# UNITED STATES PATENT AND TRADEMARK OFFICE

APPLICATION NO.	FILING DATE	FIRST NAMED INVENTOR	ATTORNEY DOCKET NO.	CONFIRMATION NO.				
10/781,180	02/18/2004	Yasutoshi Tasaka	2083.69735	1822				
7590 10/15/2007								
Patrick G. Burns, Esq. GREER, BURNS & CRAIN, LTD. Suite 2500 300 South Wacker Drive Chicago, IL 60606		<table border="1"><tr><td>EXAMINER</td></tr><tr><td>NGUYEN, HOAN C</td></tr></table>			EXAMINER	NGUYEN, HOAN C		
EXAMINER								
NGUYEN, HOAN C								
		<table border="1"><tr><td>ART UNIT</td><td>PAPER NUMBER</td></tr><tr><td>2871</td><td></td></tr></table>			ART UNIT	PAPER NUMBER	2871	
ART UNIT	PAPER NUMBER							
2871								
		<table border="1"><tr><td>MAIL DATE</td><td>DELIVERY MODE</td></tr><tr><td>10/15/2007</td><td>PAPER</td></tr></table>			MAIL DATE	DELIVERY MODE	10/15/2007	PAPER
MAIL DATE	DELIVERY MODE							
10/15/2007	PAPER

## Office Action Summary

### **DETAILED ACTION**

FIG. 4A

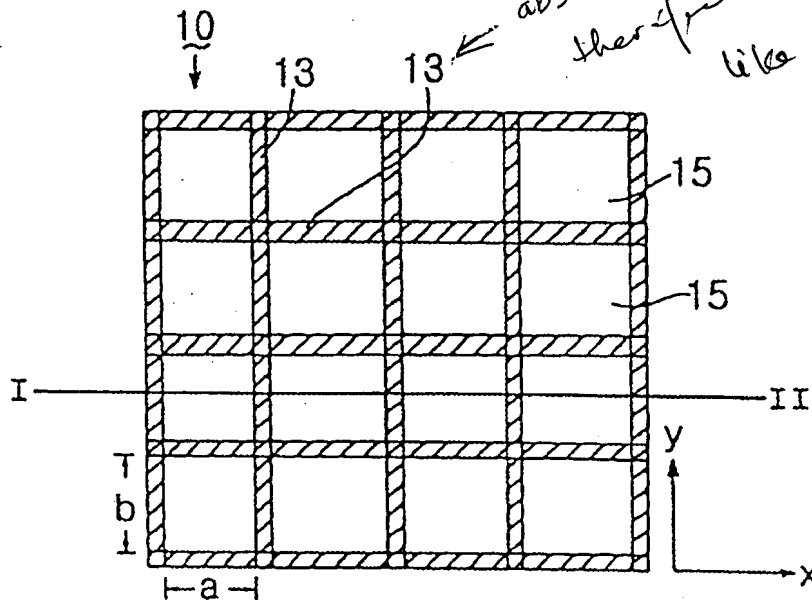
- forming an alignment layer 50 on each of said substrates 70;
- preparing a mask (including 10 and 80 as Fig. 5A shown) having
  - a body portion 10 as shown in Fig. 4B

- said cavity has a saw-toothed shape having an equilateral triangular cross-section as Fig. 4B shown.

Examiner considers the combination of the polarizer 10 disposed on the passive mask 80 as mask, which cited in claims 26-27 and 29.

wherein **the polarizer holders 13 are made of optically absorptive material** (col. 4 lines 4-5) thus the polarizer holders 13 act as the light shielding in the mask configuration. Therefore, the polarizer 10 itself can perform as the mask, which has structure of square-lattice structure.

Second, the combination of the polarizer 10 disposed on the passive mask 80 will consider as a mask, which comprising a plurality of cavities having oblique surfaces for changing the path of light incident on the mask (see attachment).
